ENGINEERING EXHIBIT

PETITION TO DENY
THE APPLICATION OF
EDUCATIONAL MEDIA FOUNDATION
FOR A NEW FM TRANSLATOR STATION
TO SERVE
MONTECITO, CALIFORNIA
CHANNEL 206, 89.1 MHz

FCC FILE NO. BPFT-990709TA (93814)

AUGUST 24, 1999

<p>Scale in km</p> <p>0 10 20 30 40</p>	<p>KCRU BLED930225KA 206A .2kW PROPOSED FX 206D .01kW NON-DIRECTIONAL</p>	<p>SMCCD - KCRU FIGURE 1</p>
---	--	---

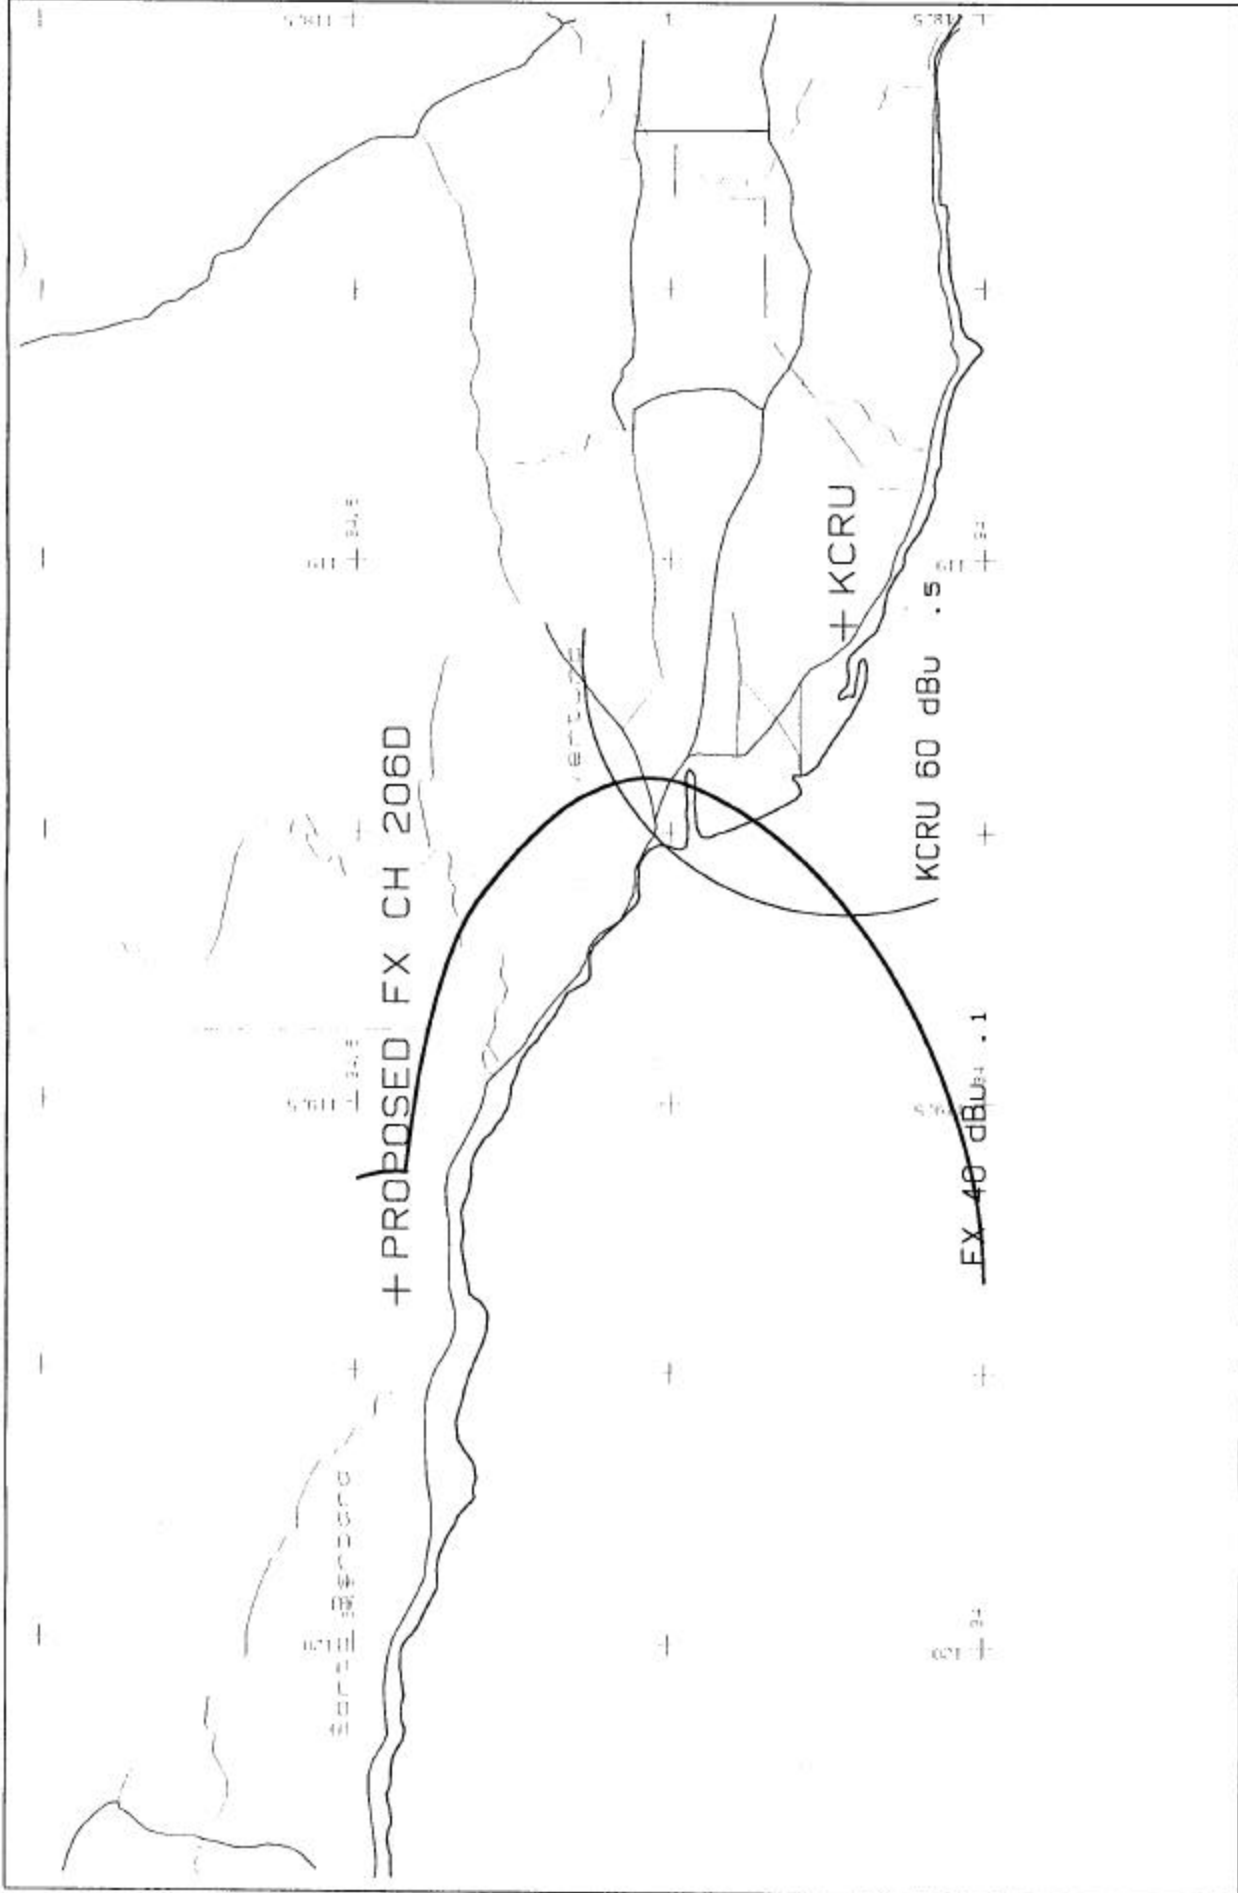
There are several errors in EMF's application which makes it difficult to determine what exactly EMF is proposing. The application states that a Scala Model CA2-CP, a circularly polarized directional antenna, orientated at 180°, will be used but the coverage data contained in Section II, Paragraph 10, of FCC Form 349 and the 60 dBu coverage contour (EMF's Exhibit B) have no relationship to the CA2-CP antenna data. In fact, the coverage contour (EMF's Exhibit B) is for a non-directional antenna. If EMF is proposing to use a non-directional antenna, then there will be prohibited contour overlap with KCRU. Figure 1 shows the overlap of the proposed translator's 40 dBu interference contour with the 60 dBu protected

contour of KCRU. The contour overlap is quite significant. If EMF is actually proposing to use the Scala CA2-CP antenna then this contour overlap will be eliminated but not the interference to KCRU listeners in the Santa Barbara and Montecito areas.

SMCCD - KCRU
FIGURE 2

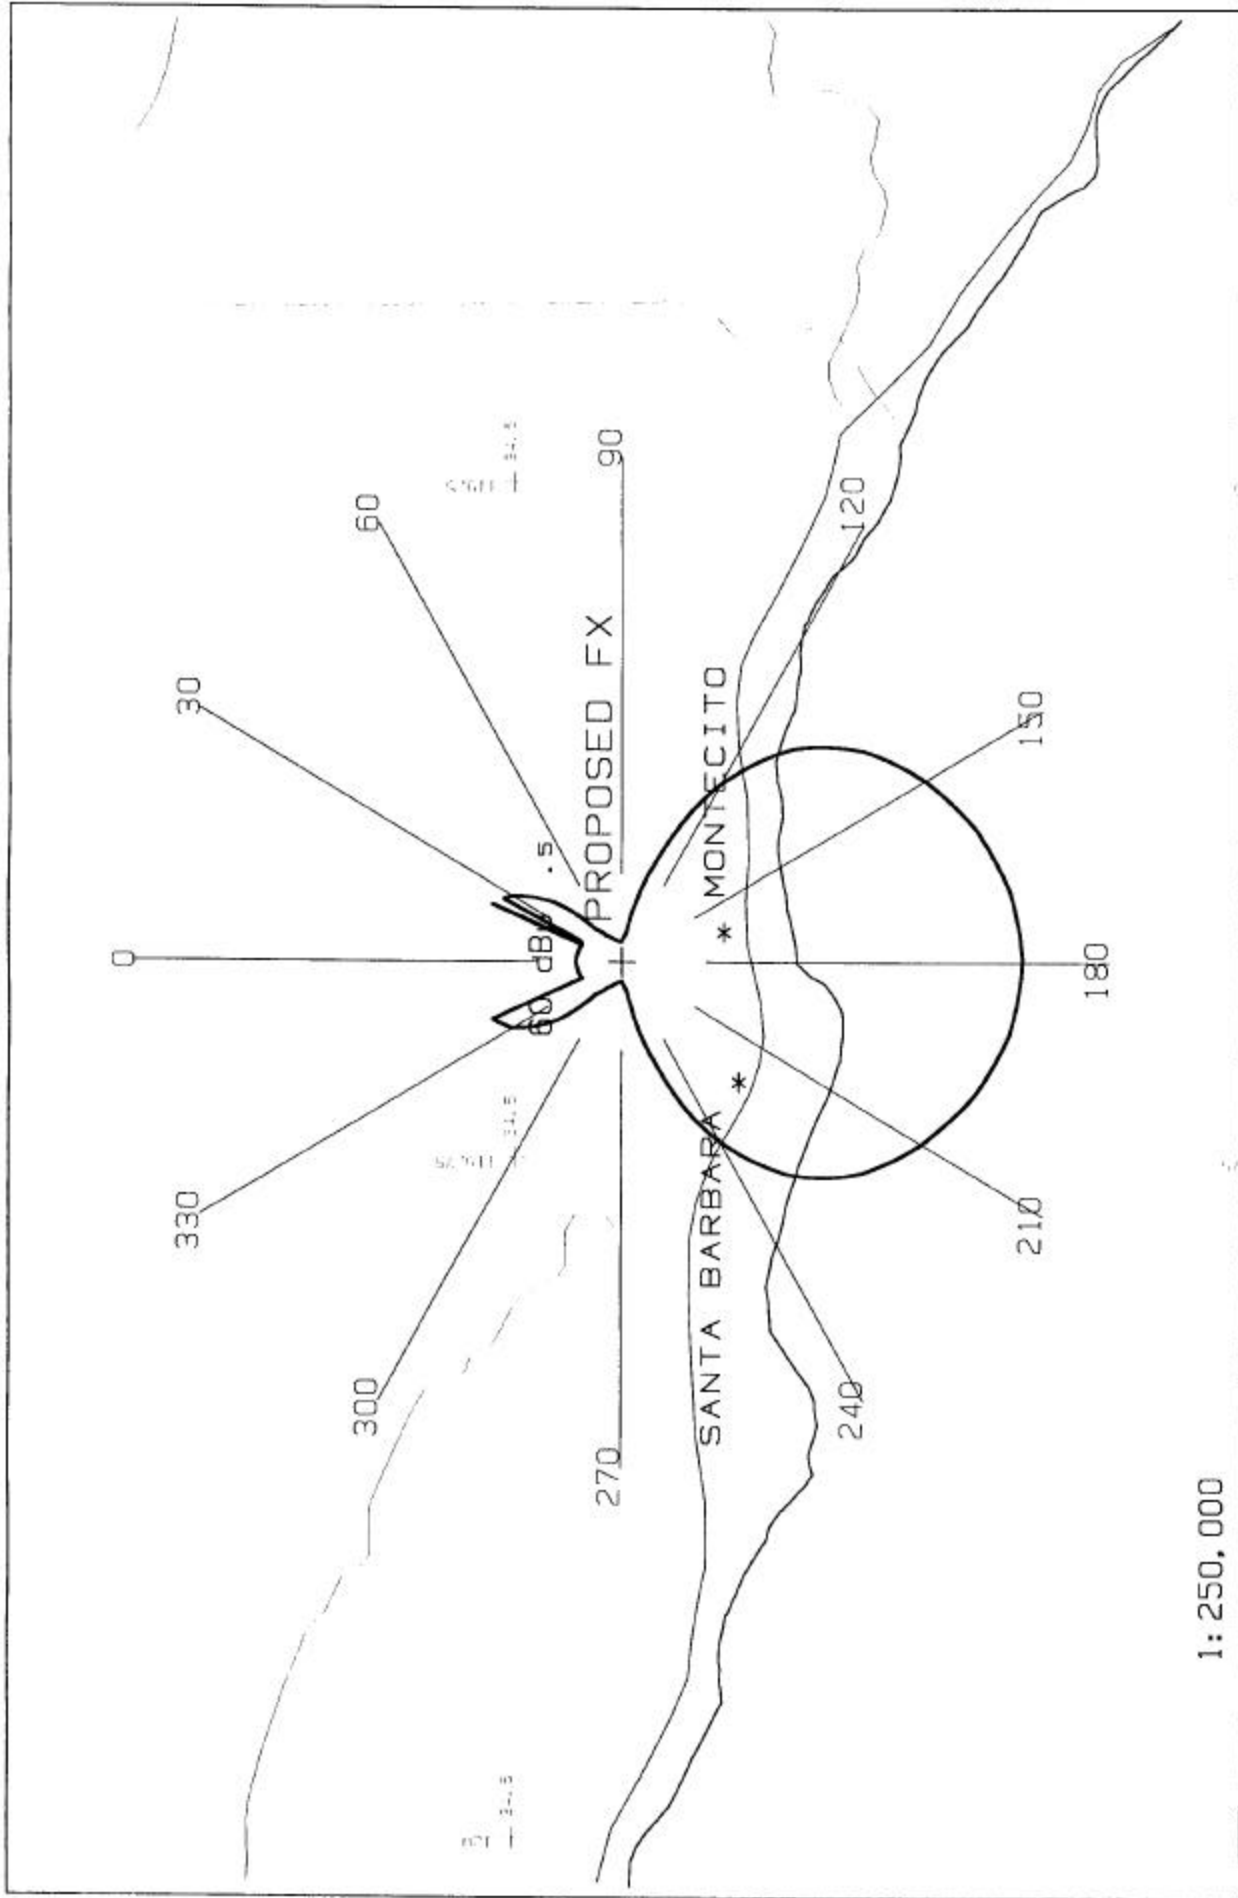
Since it is impossible to know exactly what EMF is proposing, the interference analysis of this exhibit will be based upon the use of the Scala CA2-CP antenna, orientated at 180°, with an ERP of 10 watts and with an antenna height of 652 meters AMSL. The 60 dBu coverage contour, based upon the use of the Scala CA2-CP antenna, is shown in Figure 2.

Even if EMF is actually proposing the use of a Scala CA2-CP antenna, orientated at 180°, there will be interference to all of KCRU's listeners within the proposed translator's 60 dBu contour (Figure 2). Section 74.1204(f) of the Commission's Rules states:

KCRU has a sizeable listenership and subscriber base within this contour, which includes almost all of Santa Barbara and Montecito. Listed below are the zip codes represented within the proposed translator's 60 dBu contour. Also, shown is the number of KCRU subscribers residing within those zip codes:
